March 3, 2023

**RE: Response to Adequacy Review Comments for Martin Marietta Materials, Inc., Windsor East Mine,
File No. M-2022-042, 112c Permit Application**

This letter is in response to your Adequacy Review letter, dated December 4, 2022, regarding Martin Marietta's 112c Permit Application for the Windsor East Mine (File No. M-2022-042). Please find below our responses to the Adequacy Review comments.

C-1

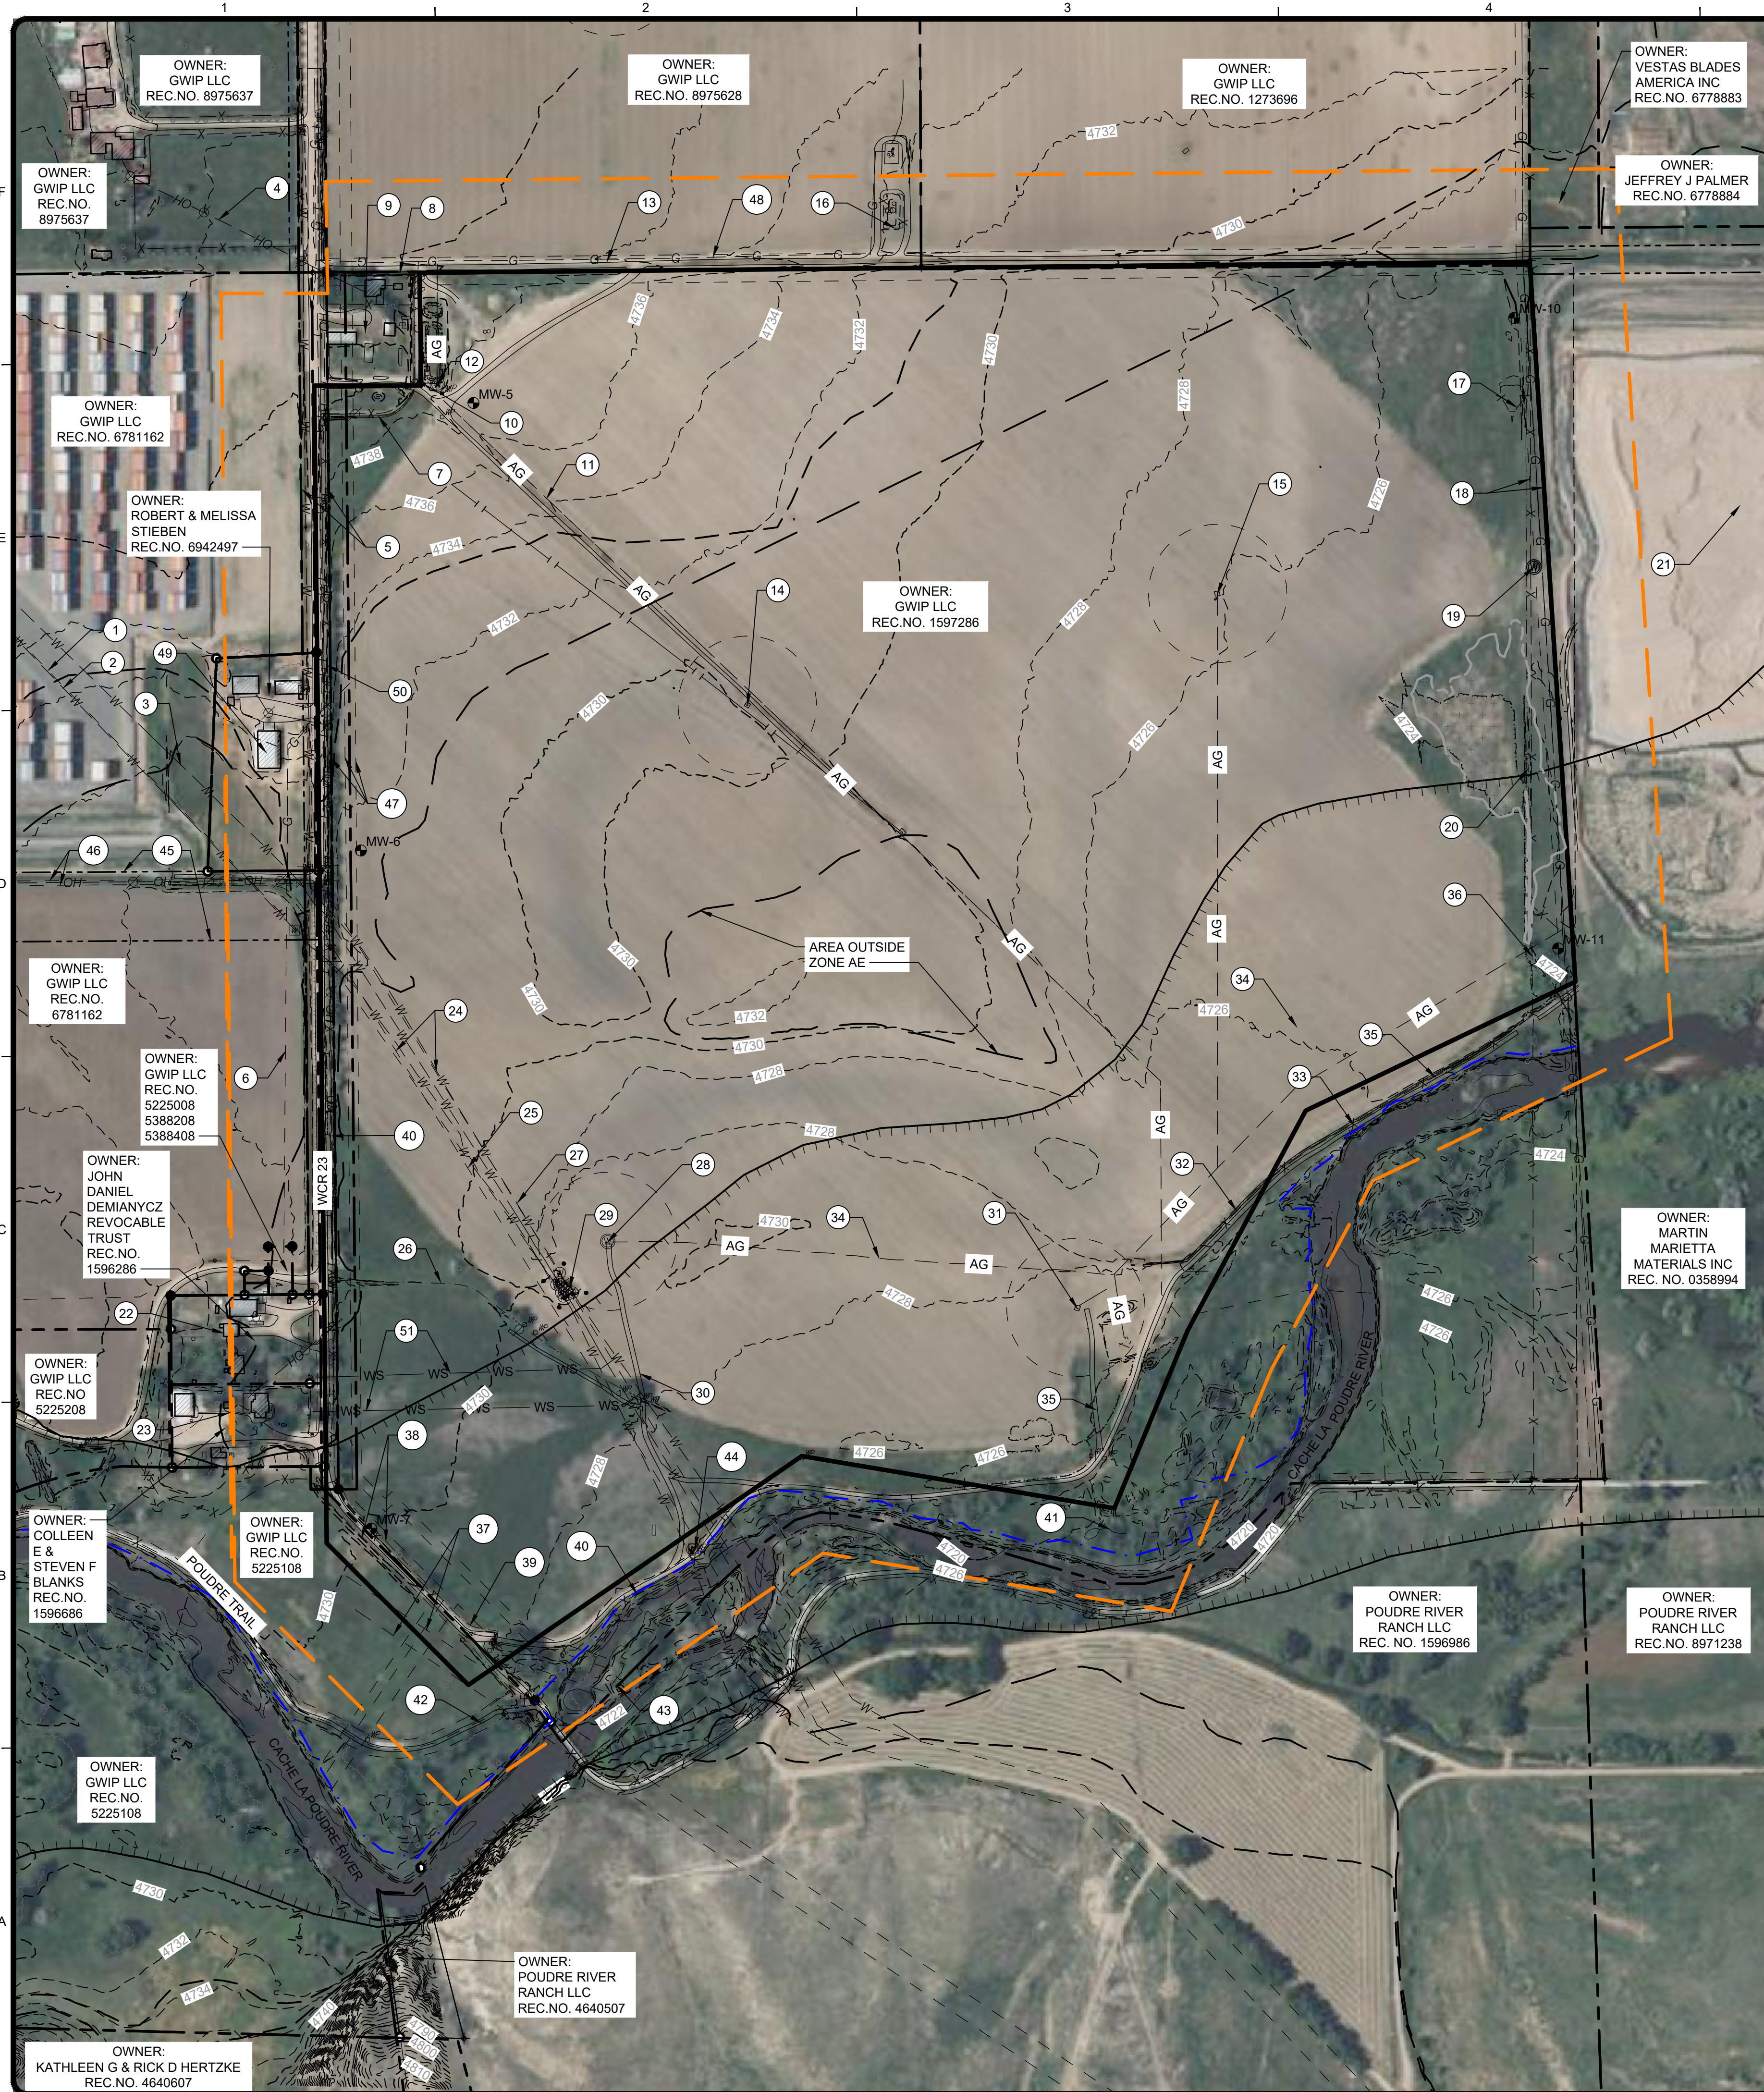
- Exhibit C: We added some potential water service lines (structure number 51) to sheet C-2. The City of Greeley's historic mapping shows these lines; however, the property owners that are connected to the lines indicated they do not exist as Greeley's mapping shows. The service lines would need to be potholed to locate them. This will be completed prior to mining. If the lines are found to be located where the City of Greeley's mapping shows them to be, the lines will either be relocated or Cell D will not be mined.
- Exhibit F: The reclamation topography for the water storage reservoirs was modified to incorporate more curves at the shoreline. In changing the topography, the size of the reservoirs slightly decreased. The acreage information was updated on both sheets of Exhibit F.
